## 8. COA-057293-2019

2110 M Street

# Commission of Architectural Review

STAFF REPORT

Figure 1. Sanborn map, 1905

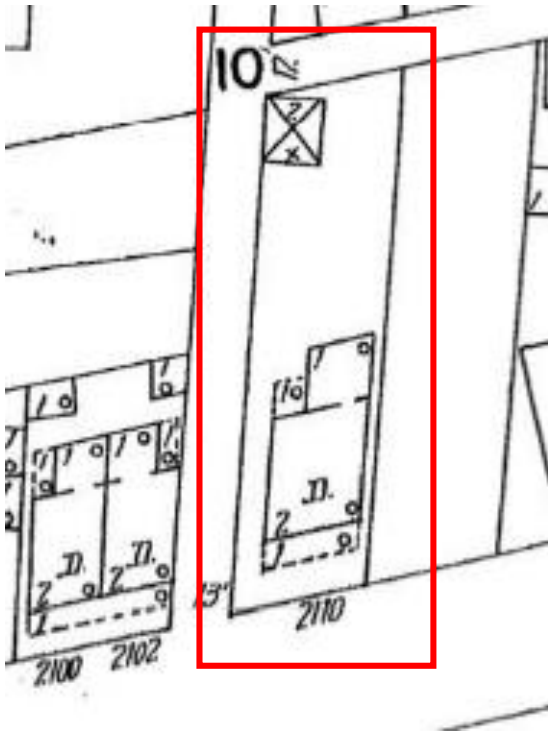
Standards for Rehabilitation, pg. 59 #10	<i>...it is acceptable to use salvaged materials as in-kind replacement...</i>	As the windows in the rear are going to be removed to alter the openings and to accommodate the addition, <u>staff recommends that the historic windows removed be used for any window replacement or repair needed on the more visible elevations and an unused windows be maintained on the property.</u>
Standards for New Construction, Siting, pg. 46 #1	<i>Additions should be subordinate in size to their main buildings and as inconspicuous as possible. Locating additions at the rear or on the least visible side of a building is preferred.</i>	The proposed addition is located at the rear of the building, is subordinate in size, and is differentiated from the historic building by a 6" inset.
Standards for	<i>...adding features or salvaged architectural</i>	Sanborn maps indicate that a one-story porch

Rehabilitation, pg. 59 #10	<i>elements that suggest an inaccurate or undocumented sequence of construction should be avoided because this confuses our understanding of the evolution of Richmond's historic built environment.</i>	was located in the rear corner of the building, and by 1925 an addition had been added above the porch, as exists now. The applicant has designed the new rear addition to appear as an enclosed porch. As research indicates that the building did not possess a two-story rear porch in this location, <u>staff recommends the addition be clad in fiber cement siding with a different reveal to distinguish it from the historic portion, and the shutters and bead board be removed from the design.</u>
Fences and Walls, pg. 78 #1	<i>Original fences and walls should be retained and maintained whenever possible.</i>	There is a concrete retaining wall and steps at the front of the home. The application does not address any site or landscaping improvements so <u>staff recommends the concrete retaining wall remain as existing and any proposed landscaping be submitted to staff for administrative review prior to installation.</u>

- The first story window on the side elevation be replaced with a 2/2 wood or aluminum clad wood window with true or simulated divided lights with interior and exterior muntins and a spacer bar between the glass.
- The new fenestration on the rear elevation be vertically aligned, to match the historic pattern.
- The historic windows removed be used for any window replacement or repair needed on the more visible elevations.
- The addition be clad in fiber cement siding with a different reveal to distinguish it from the historic portion, and the shutters and bead board be removed from the design.
- The concrete retaining wall remain as existing and any proposed landscaping be submitted to staff for administrative review prior to installation.
- The rear porch depth be reduced to six feet.
